DEPARTMENT OF PLANNING AND ZONING

RE: DSUP #2016-0007 - Fillmore/St. James Phasing Amendment - Completeness Review

PLANNING AND ZONING

Emergency Vehicle Easements

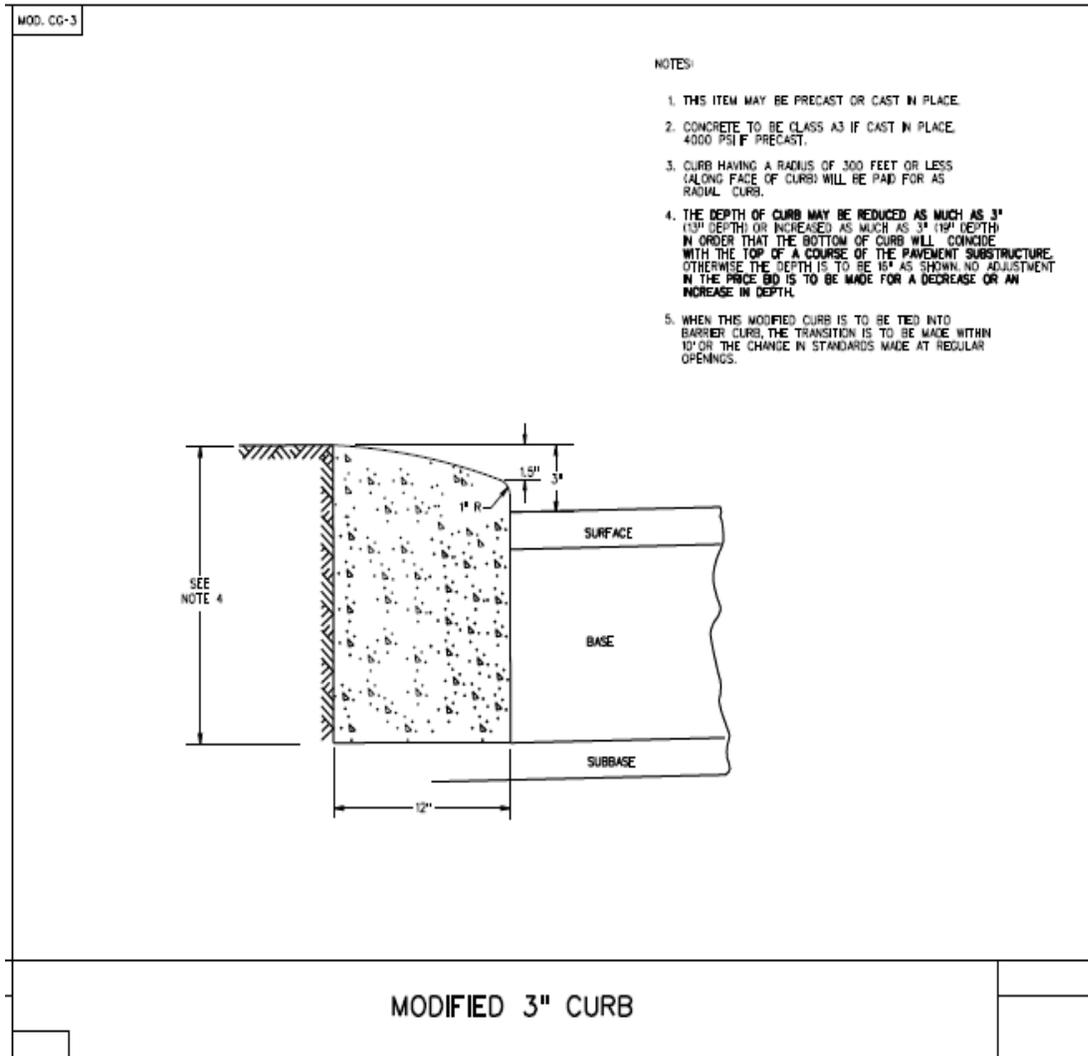
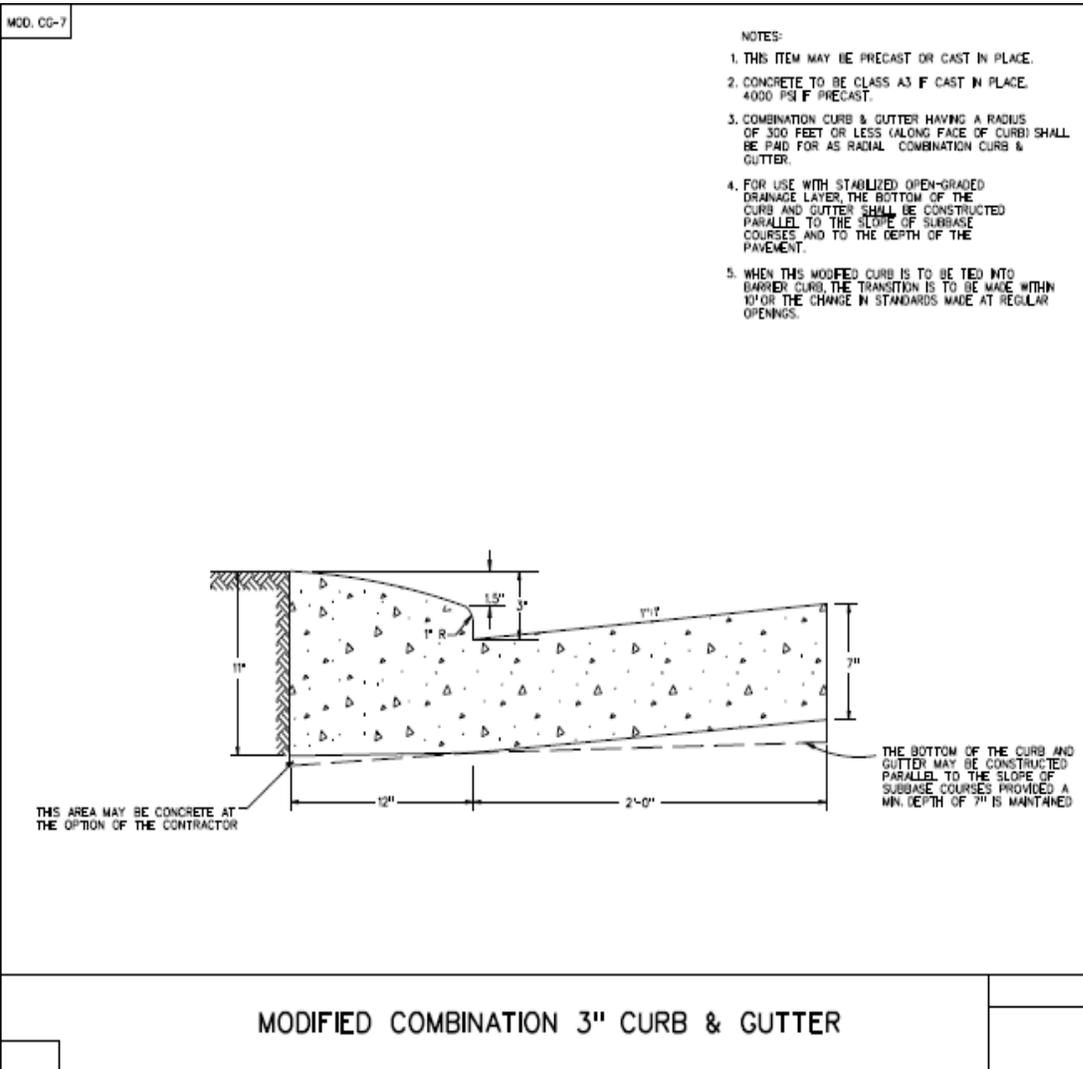
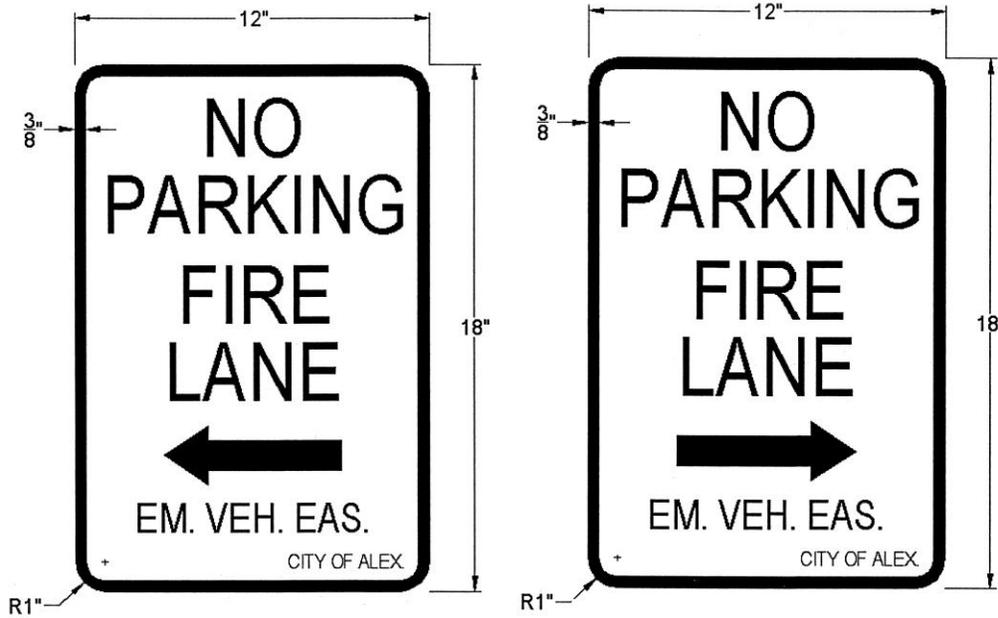
- C-7 The final site plans shall show placement of emergency vehicle easement signs. See sign detail and placement requirements below.

Applicant indicates a mountable curb will be installed at “T”. One of the above design shall be used for the curb. Will be on final site plan.
